CONSTRUCTION PLANS FOR CARRIAGE MEADOWS SOUTH AT LORSON RANCH

STREET, STORM SEWER, AND POND CONSTRUCTION PLANS

COVER SHEET
STREET, STORM SEWER AND POND
CONSTRUCTION PLANS

DATE: MARCH, 2017
 PROJECT NO. 100.030
 SHEET NUMBER C6.3
 TOTAL SHEETS: 37

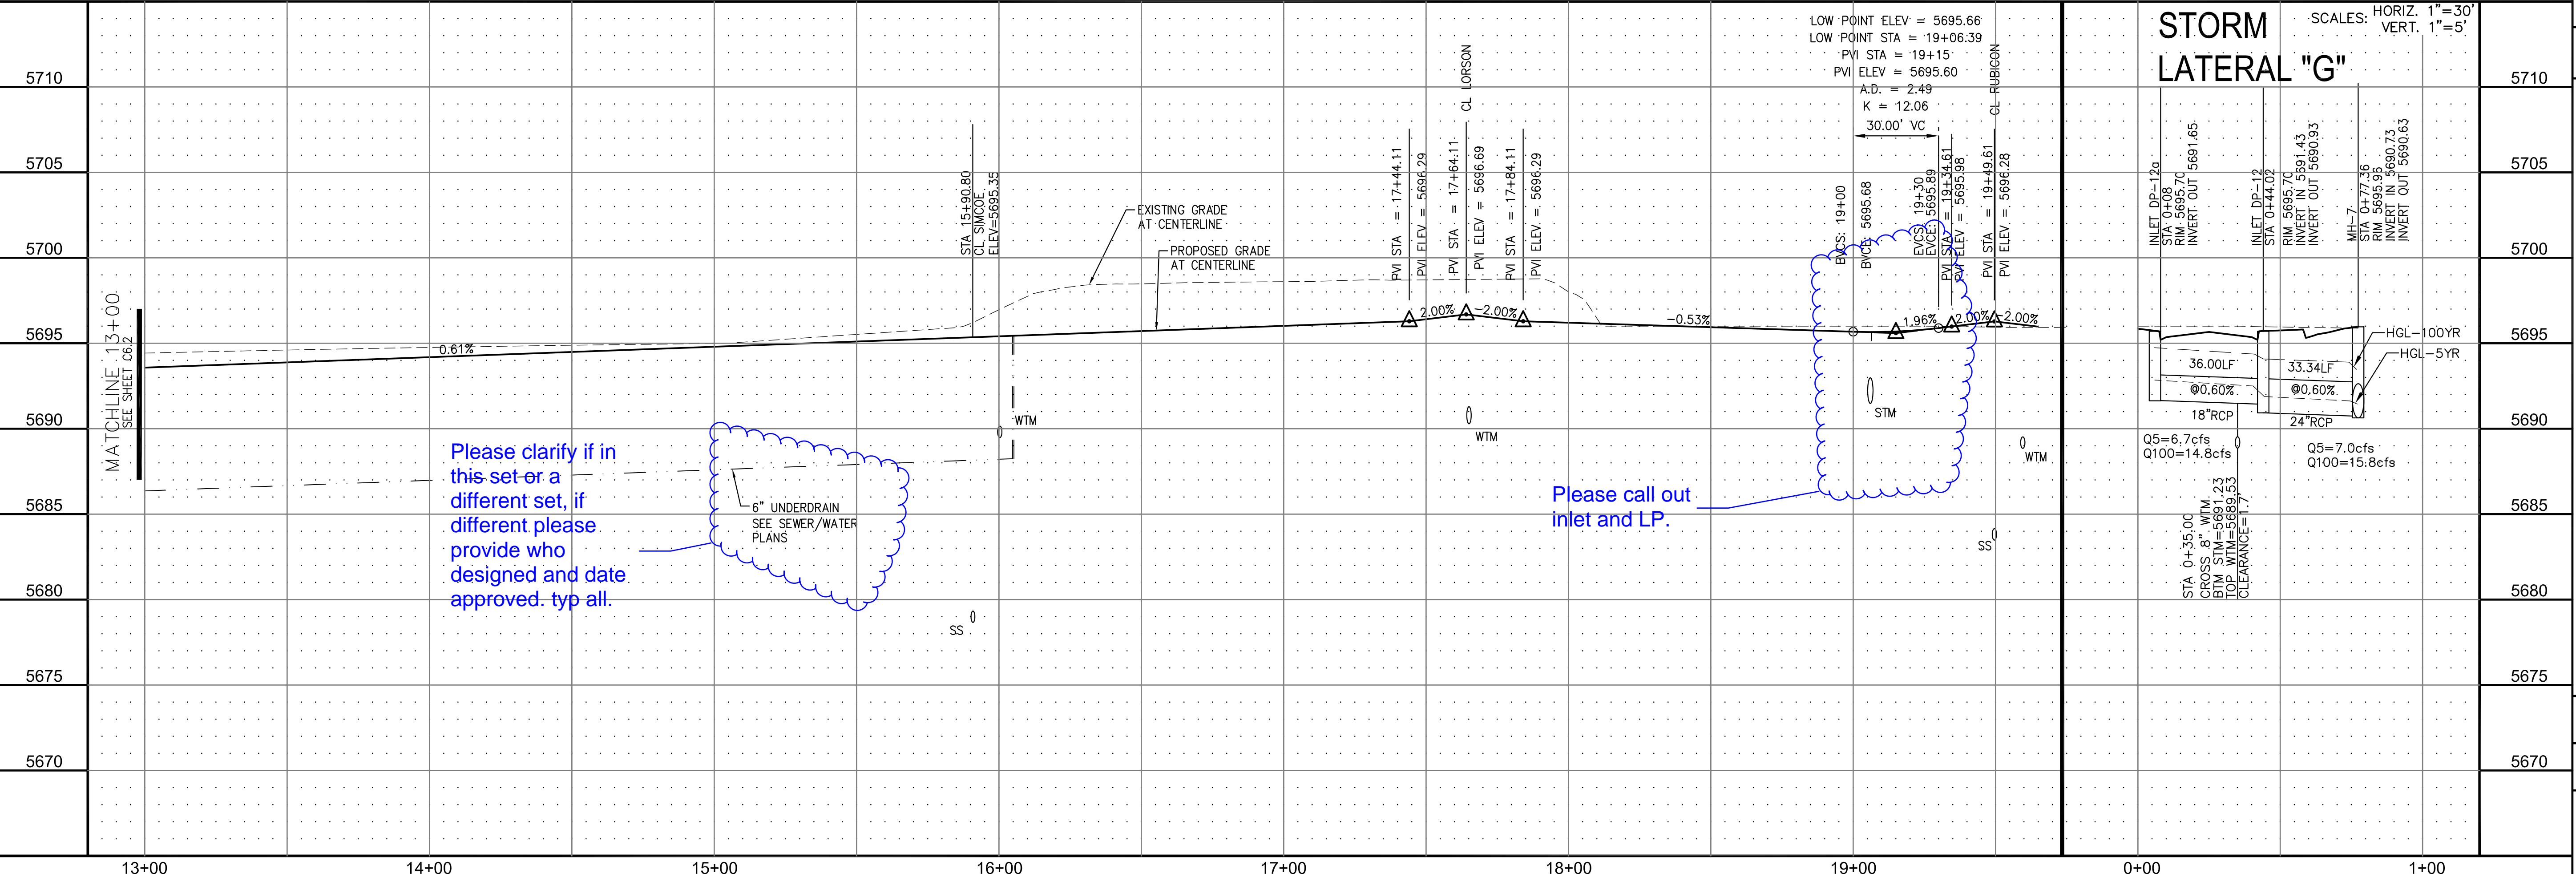
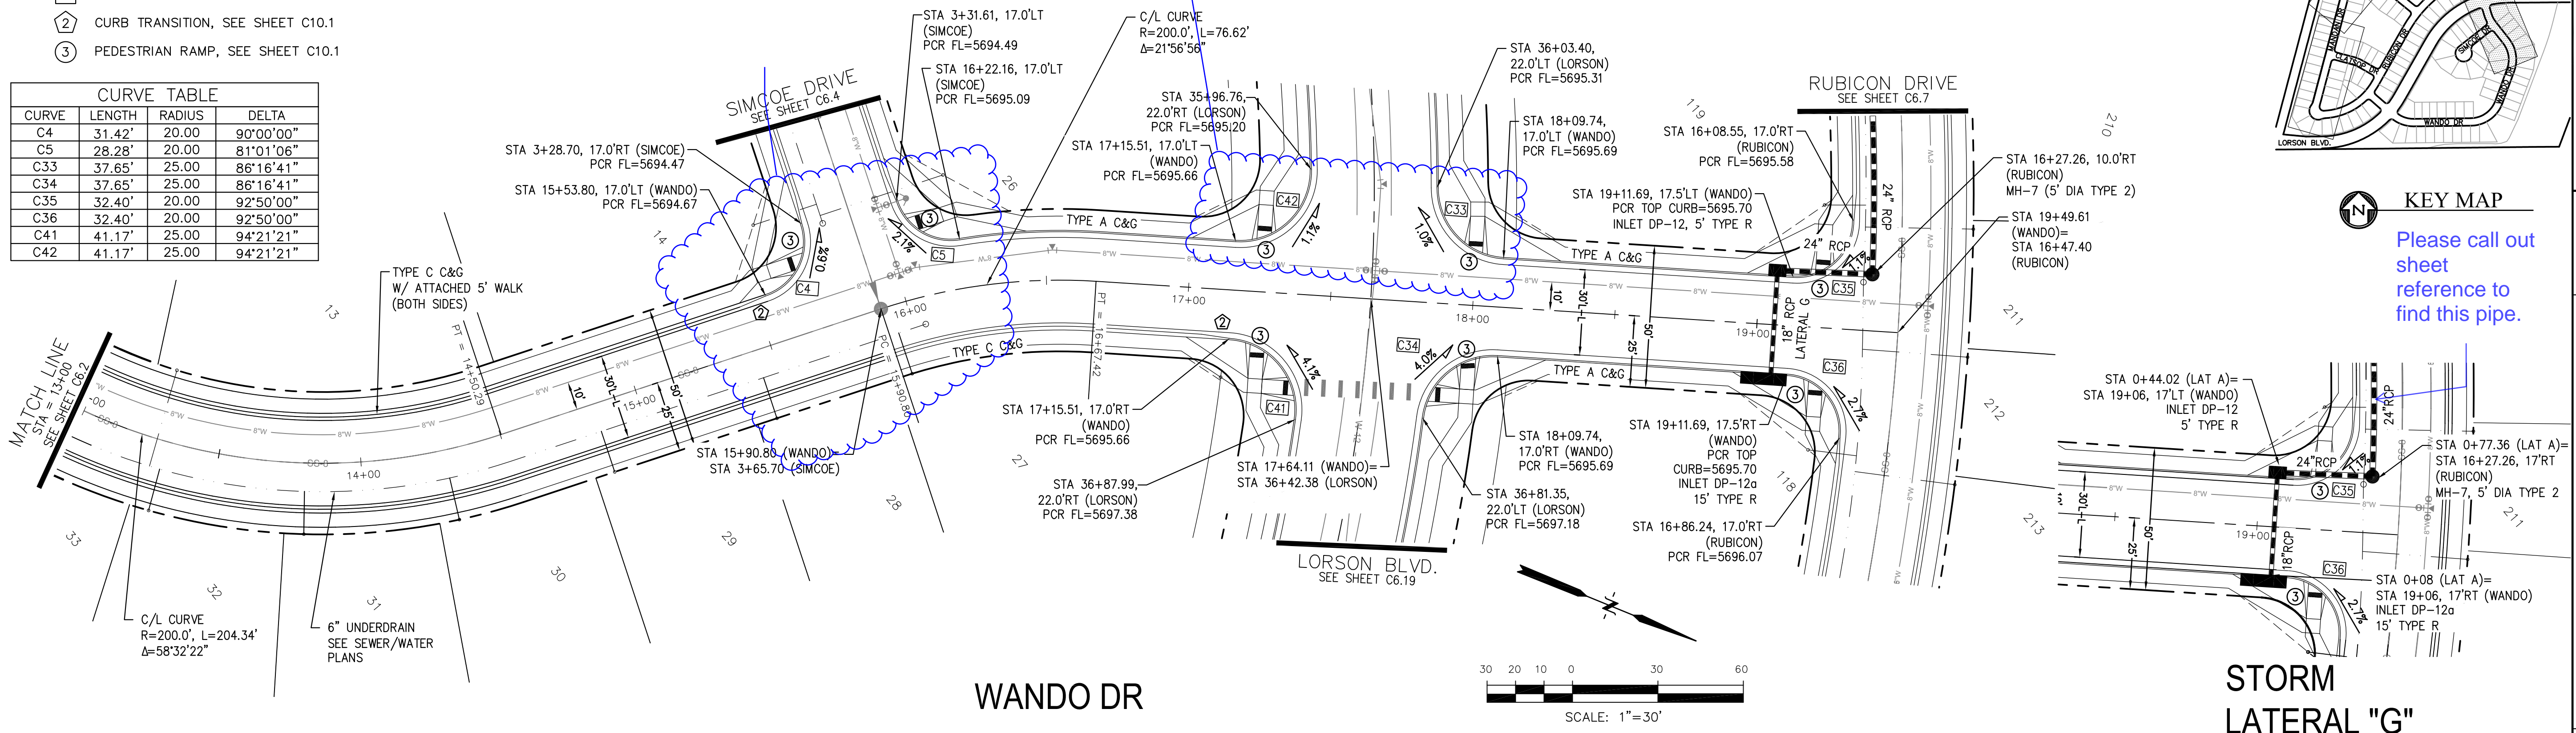
provide a pedestrian ramp crossing at this location.

Please clarify if in this set or a different set, if different please provide who designed and date approved. typ all.

Please call out inlet and LP.

DATE: MARCH, 2017
 PROJECT NO. 100.030
 SHEET NUMBER **C6.4**
 TOTAL SHEETS: 37

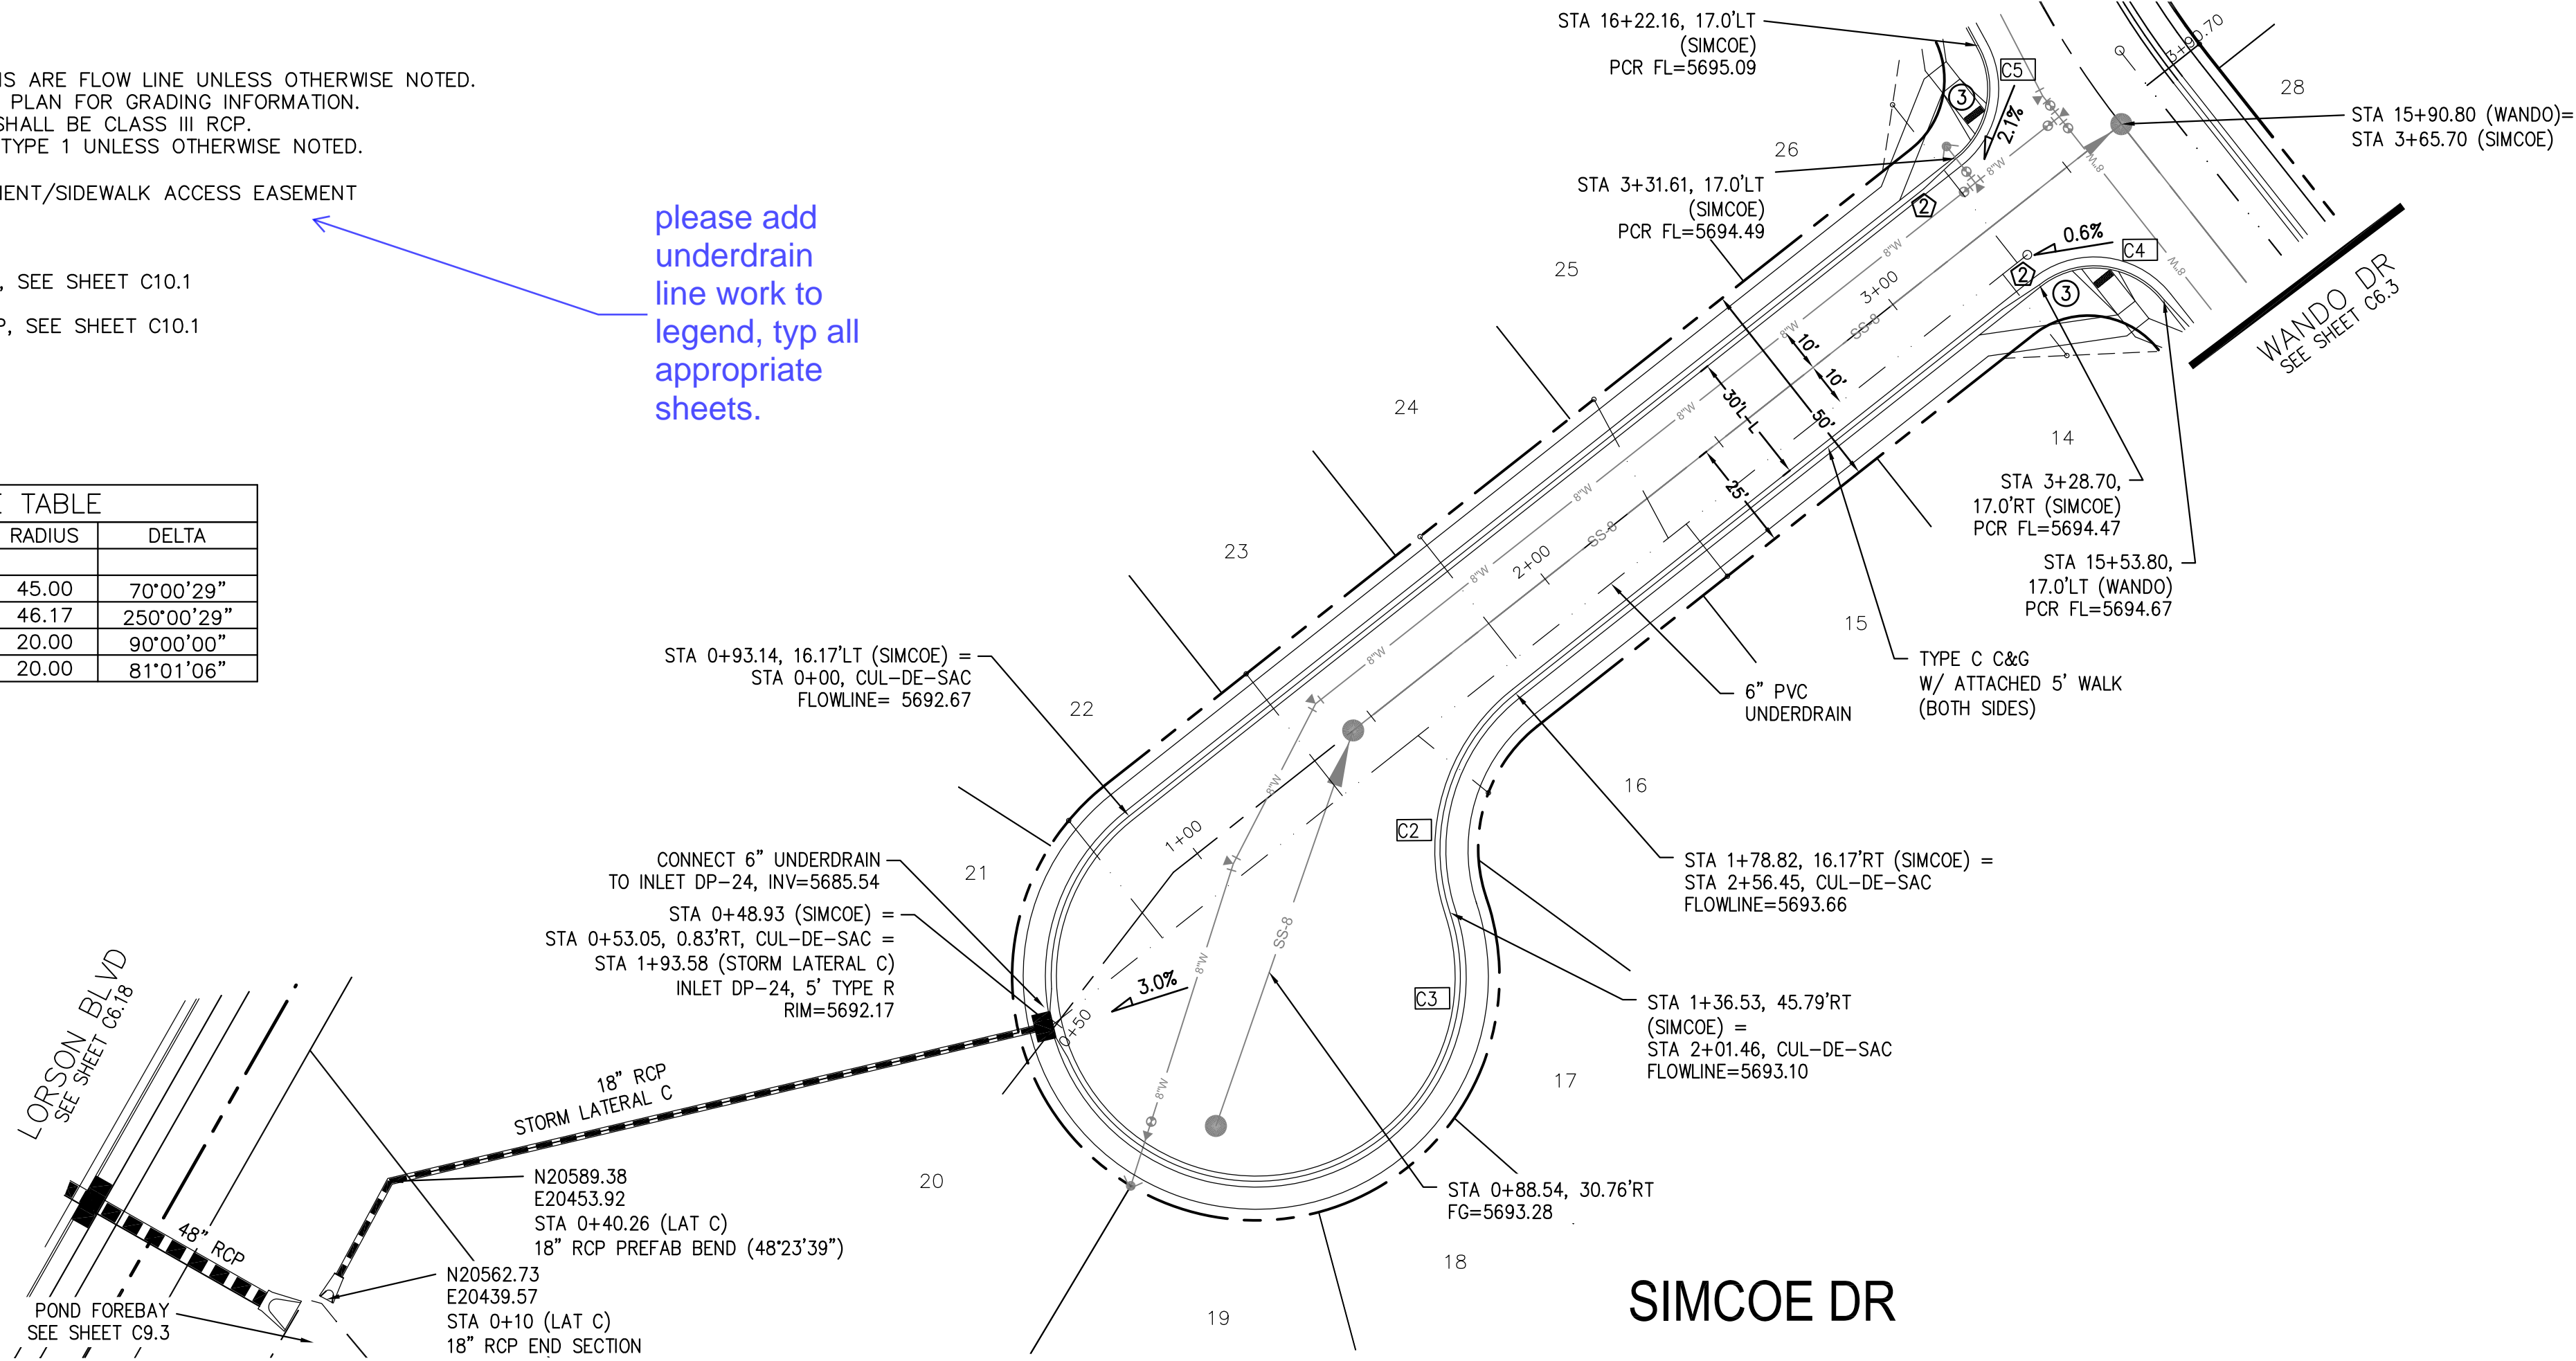
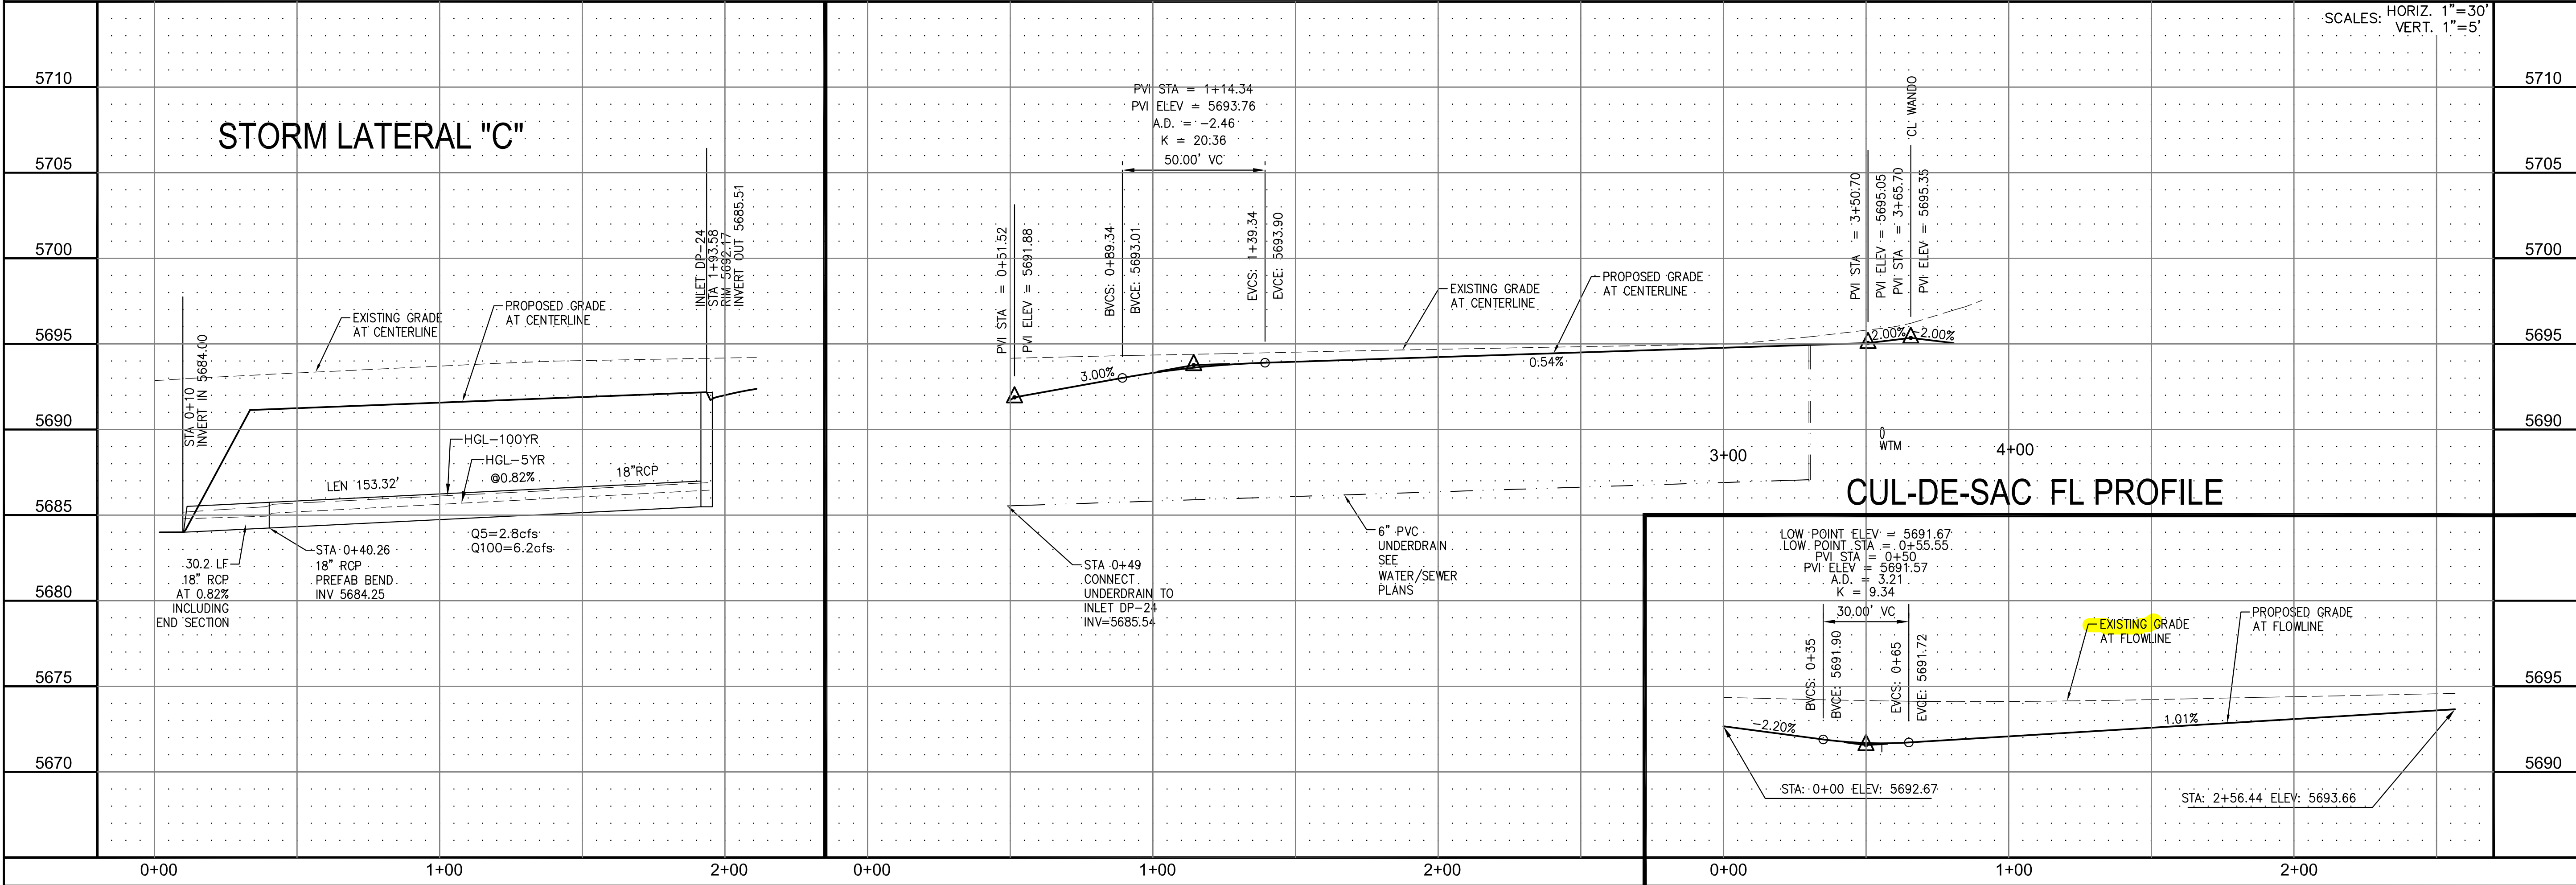
please add underdrain line work to legend, typ all appropriate sheets.
